ADDENDUM NUMBER TWO

T C ROBERSON HIGH SCHOOL CAFETERIA, PEP, AND POOL ROOF REPLACEMENTS BUNCOMBE COUNTY SCHOOLS RFP 12-16

MLA PROJECT NUMBER: 16001

DATE OF ISSUE: April 28, 2016

Cafeteria Roof Plan

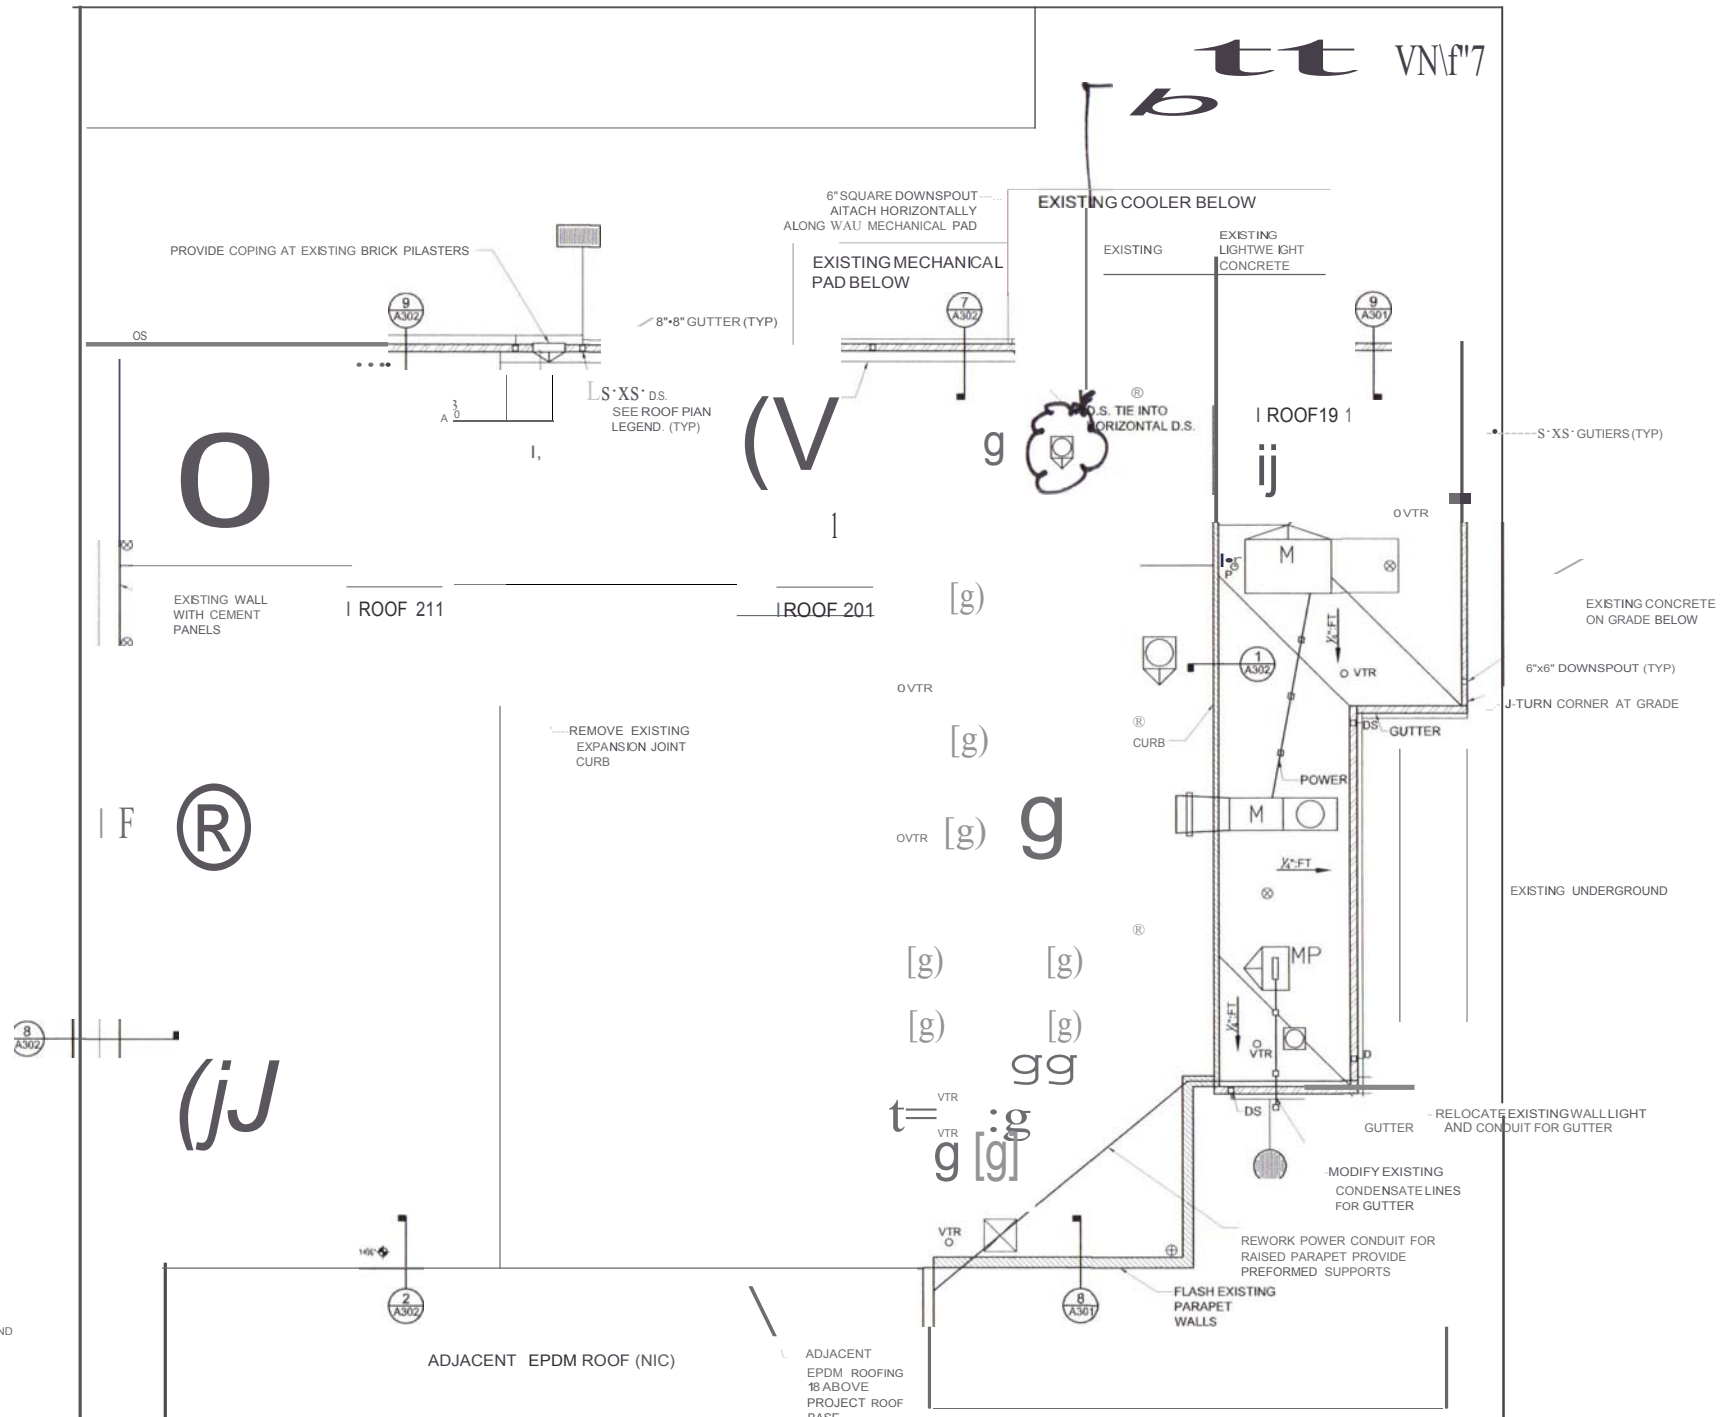
1. A201A: Remove additional roof ventilators as shown. Removal and closure is similar to curb removal in the Roof Plan Legend A201
2. Pre Bid Conference Report
3. Photos of units at Roof 19.

1. 9/A301, 6,7,9/A302: Gutter and downspout dimensions in details shall be coordinated to the gutter and downspout dimensions indicated on the roof plans
2. A201: Downspouts at Roof 19 is revised from 6" x 6" to 4"x 4"
